No.	Date	Description
1	2025-09-19	Add No. 1
2	2025-09-30	Add No. 2

**WCFPD Station 3**  
**Wright City Fire Protection District**  
9 Highway WW  
Wright City, MO 63390

1 DEMOLITION FLOOR PLAN  
AD101 1/4" = 1'-0"

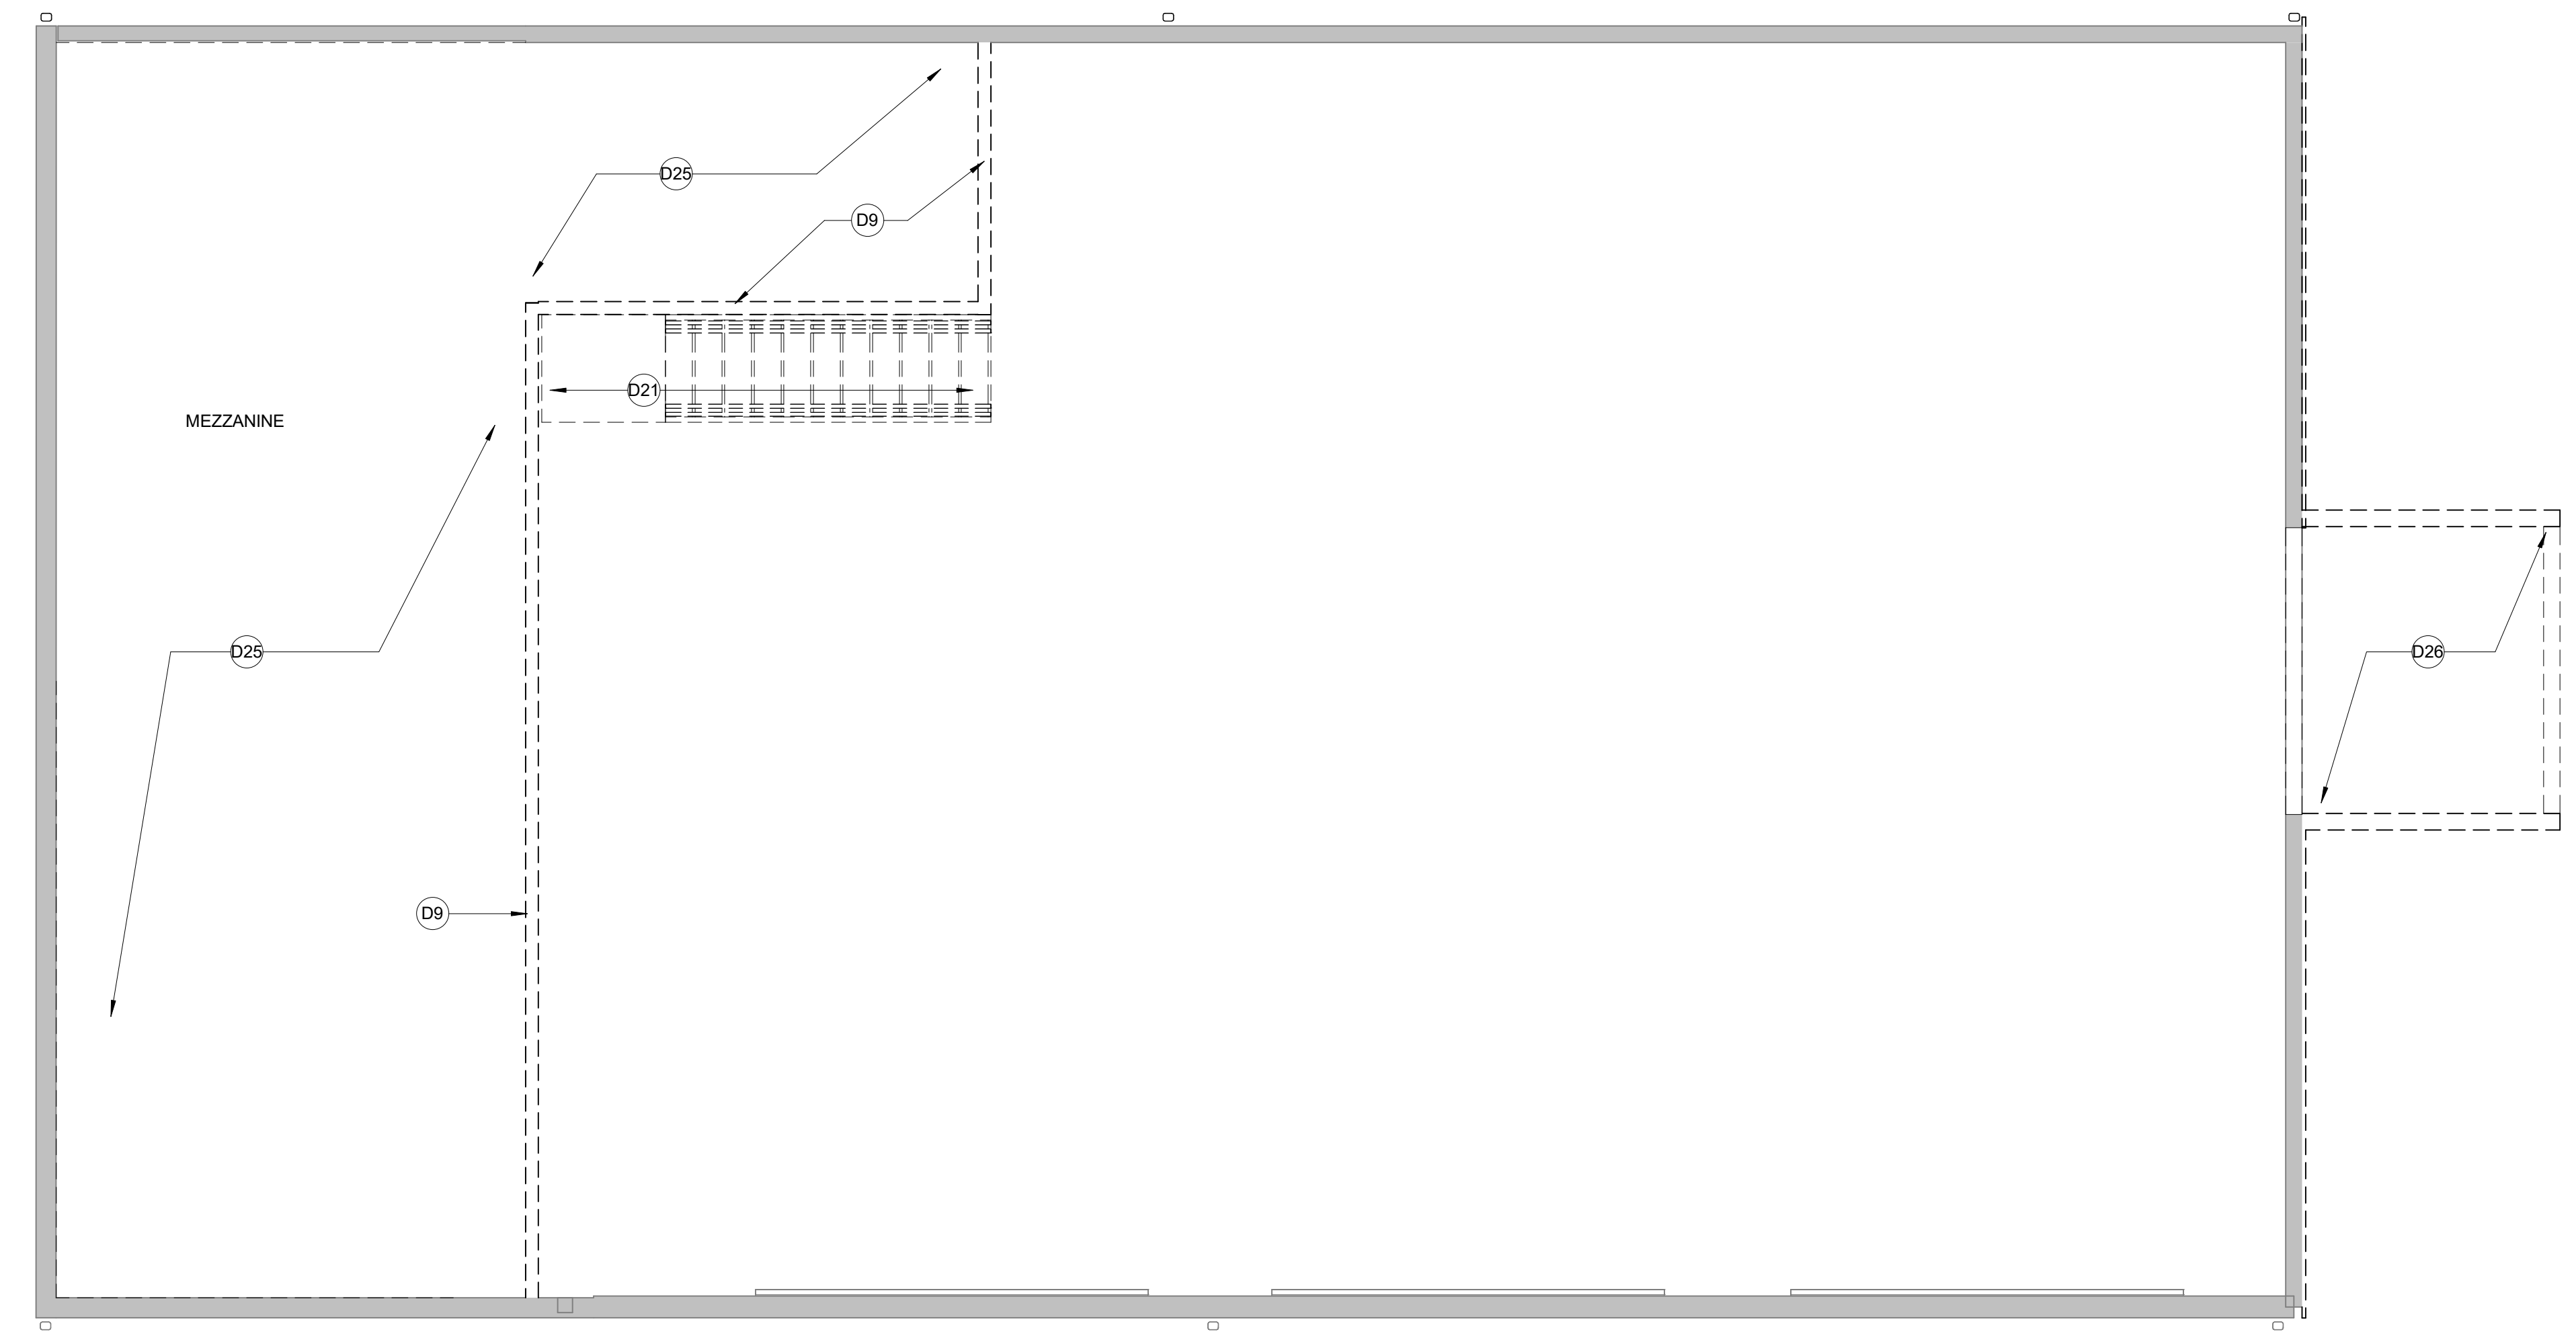
- 14) Sheet AD101 – DEMOLITION FLOOR PLANS
  - a. REVISE Keyed Noted D11, D12 and D18.
  - b. ADD Keyed Note D31 to remove existing windows and add notes to plan.

- c. ADD Keyed Note D9 to the interior mezzanine walls and the South and East walls of the mechanical room.
  - d. ADD existing pair of doors to the hose tower and add Keyed Note 13 for them to be demolished.

- e. REMOVE existing entrance door/frame/hardware.
- 15) Sheet AD102 – DEMOLITION FLOOR PLANS
  - a. REVISE Keyed Note DR5.
- 16) Sheet A101 – FIRST FLOOR PLAN

1 FLOOR PLAN  
 A101 1/4" = 1'-0"

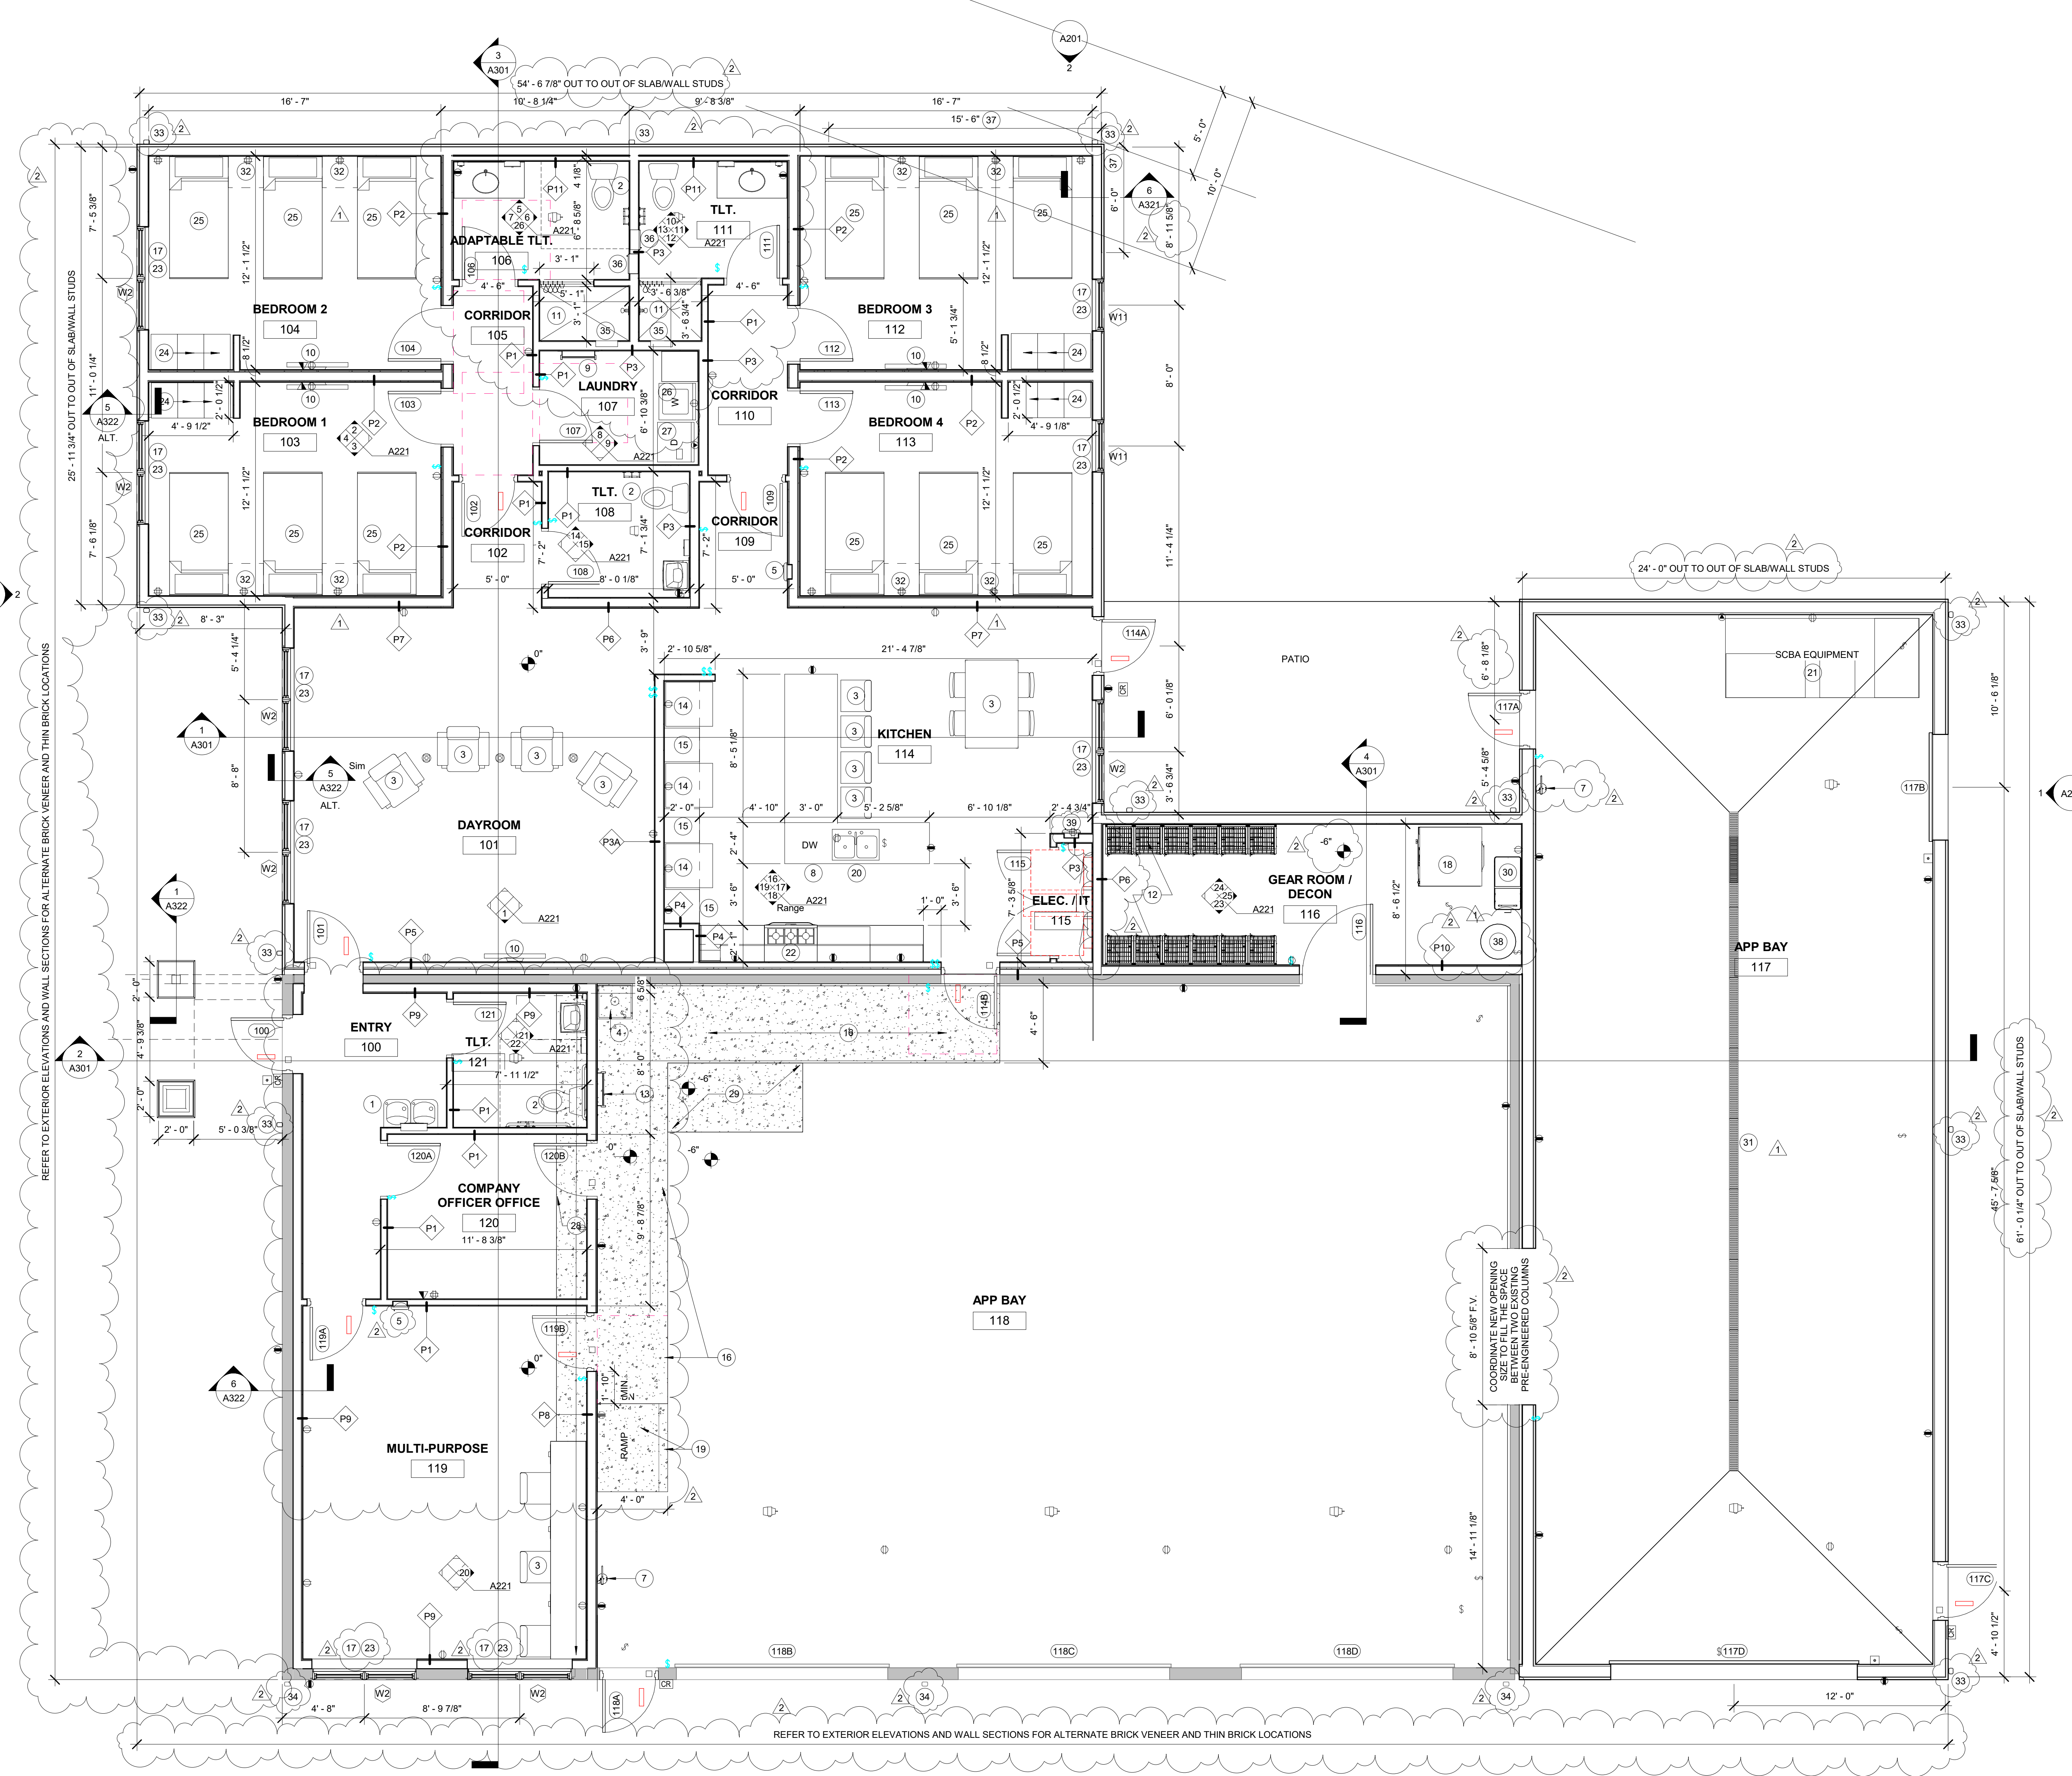
- a. MODIFY Floor Plan General Note 6.
  - b. MODIFY Keyed Notes 15 and 31.
  - c. ADD Keyed Notes 32-36 and 38-39 to the schedule and the plan.
  - d. REVISE the exterior wall dimensions to reference the same points as the structural documents.

- e. ADD furrou partition P11 to the North walls of Toilets 106 and 111. The rooms shift South and the Laundry counter gets narrower.
  - f. ADD furrou partition P9 to the North walls of Entry 100 and Toilet 121. The toilet and office shift South and the Multi-purpose room gets smaller. Consequently, the ramp in the app bay shifts South as well.

- g. ADD notations to the windows in the multi-purpose room and to the downspouts.
  - h. ADD a K-class fire extinguisher and cabinet in the Kitchen area.

- i. REVISE the West wall of the Gear/Decon room to Partition P6.
  - j. ADD a wall mounted fire extinguisher near Door 117A.
  - k. Clarified the opening size between the existing and new app bays.

- l. ADD the note regarding fireblocking.
  - m. ADD dimension notations to show extent of alternate brick veneer/thin brick.
  - n. REVISE Door 118A to a new door/frame/hardware.

**A121**

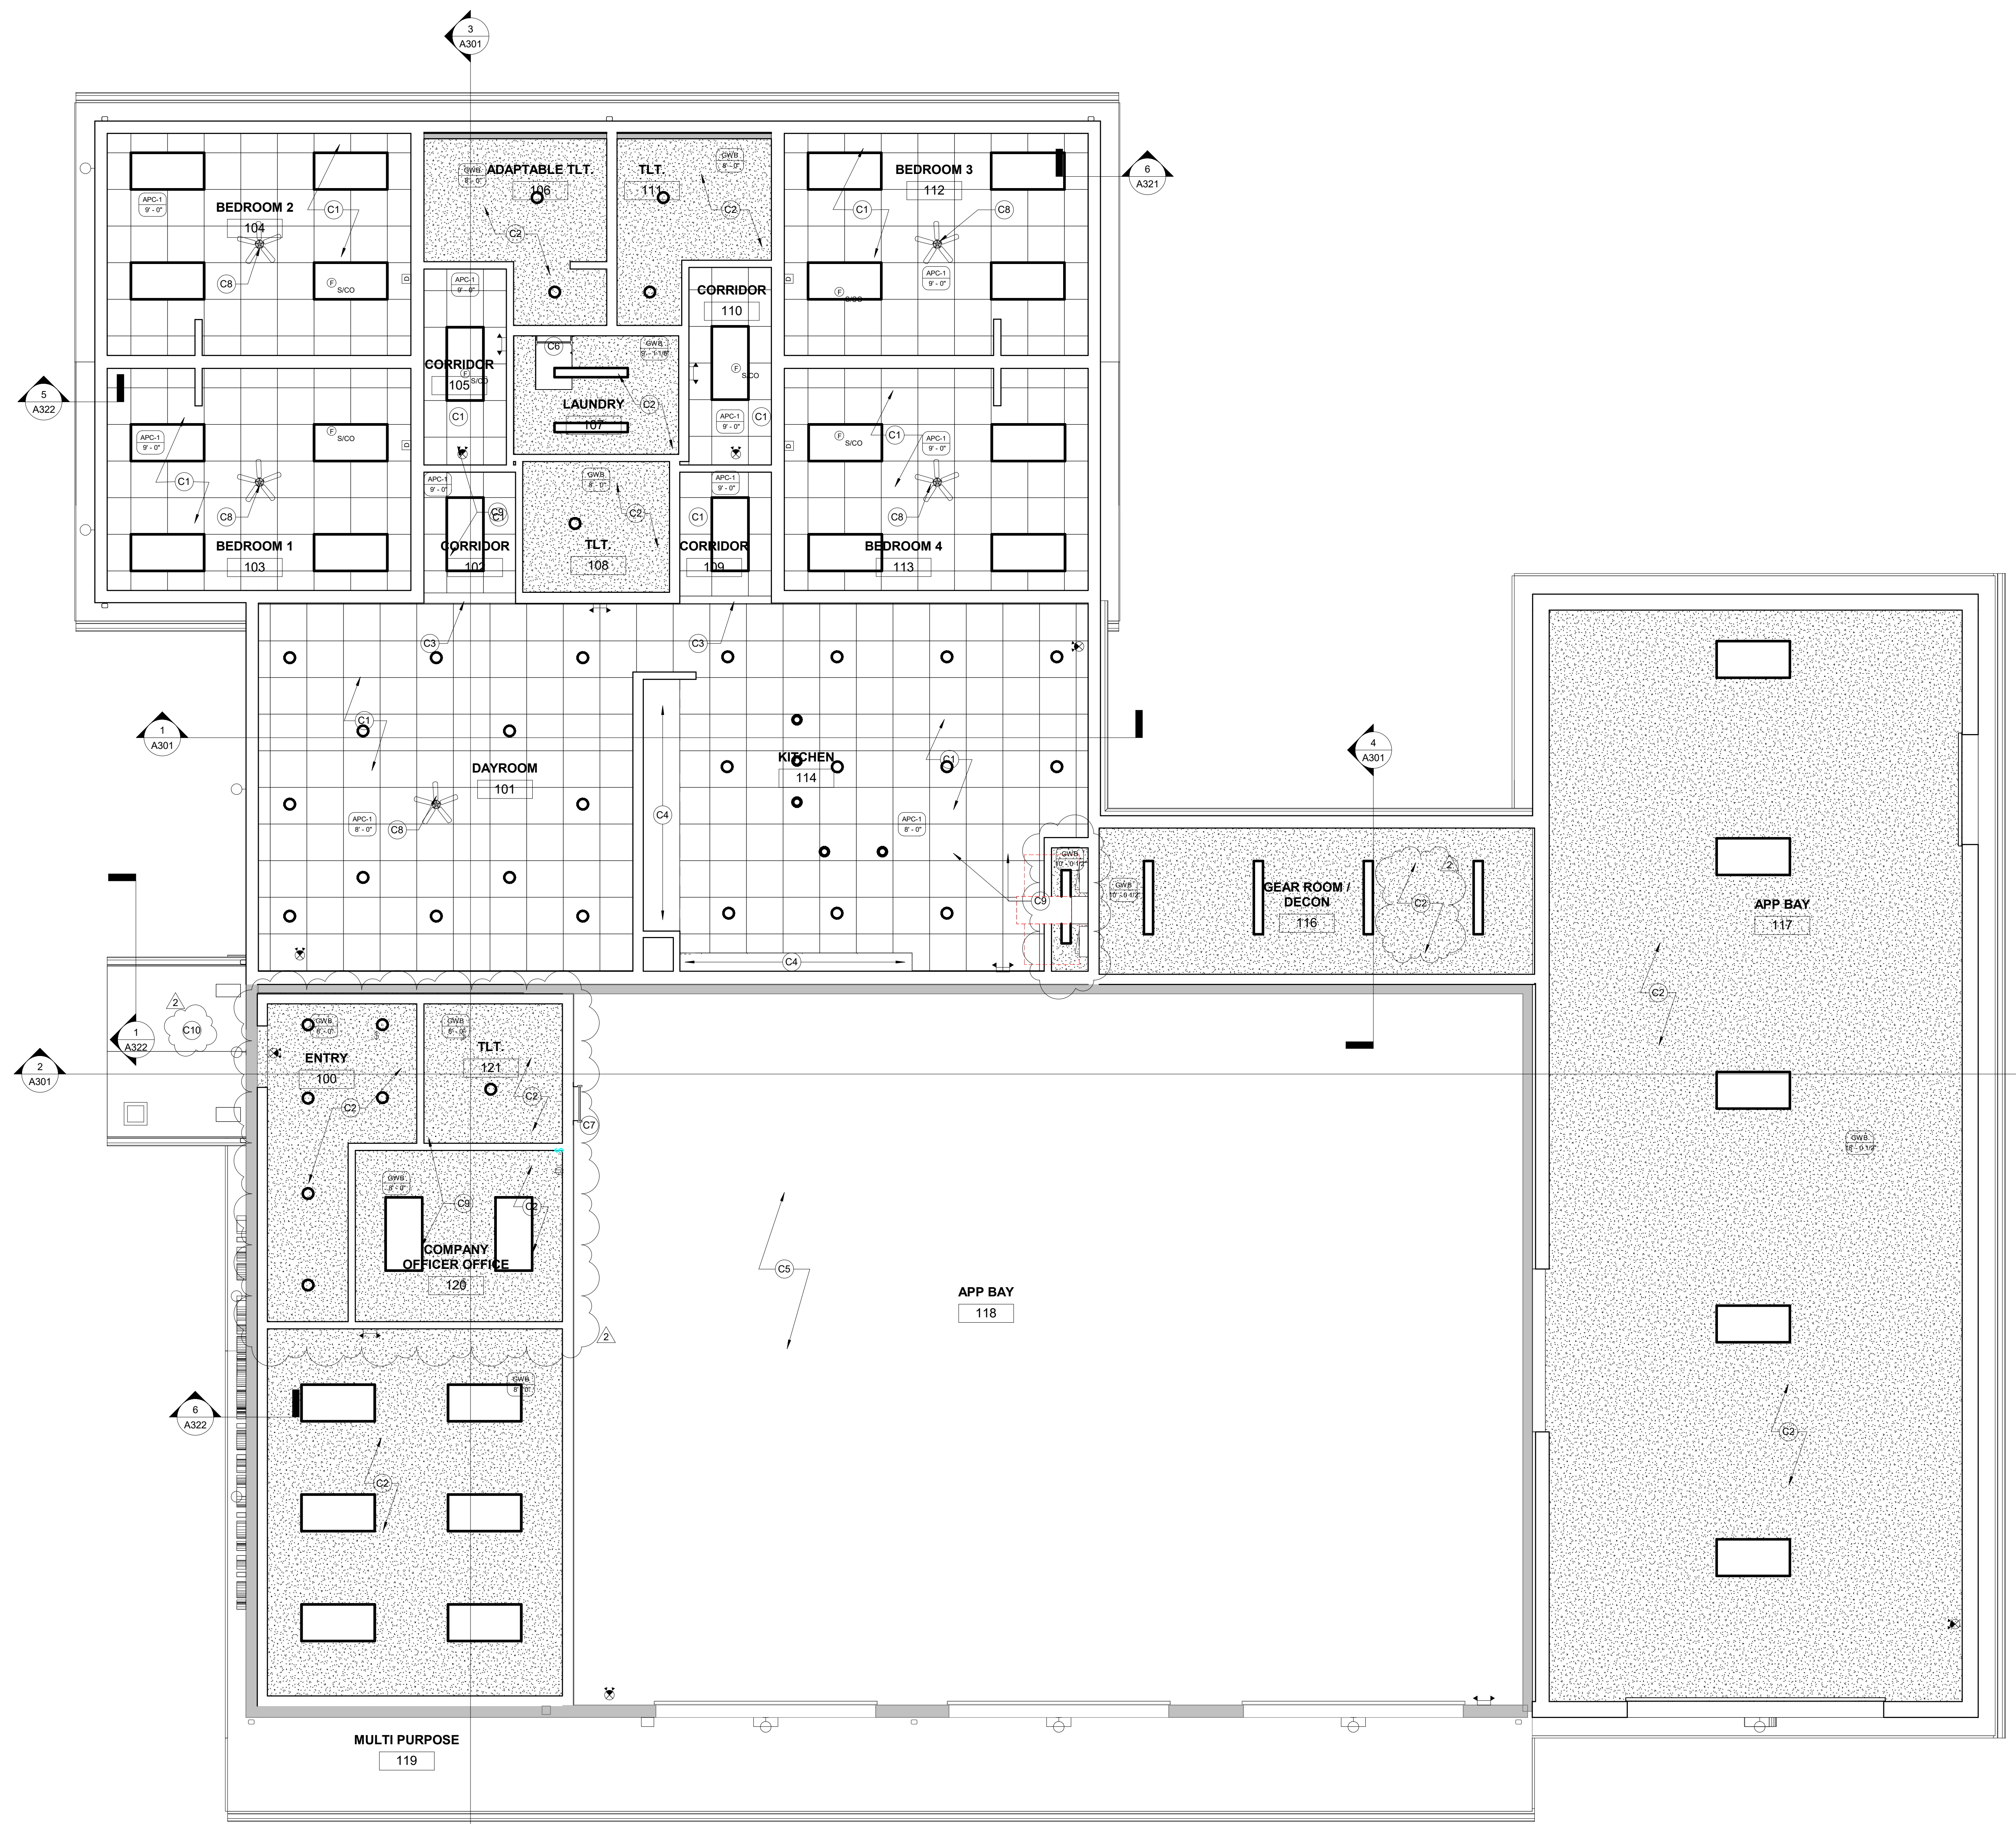
- 17) Sheet A121 – REFLECTED CEILING PLAN
- a. MODIFY General Note 4.
  - b. ADD Keyed Note C10 and add to plan.
  - c. ADD seismic ceiling suspension detail.

- d. REVISE Gear room ceiling note to C2.
  - e. ADD note for Elec Closet 115 ceiling.
  - f. REVISE Entry 100 and Toilet 121 areas per plan revision.
  - g. RELOCATE Keyed Note C7 to the mezzanine access ladder location.
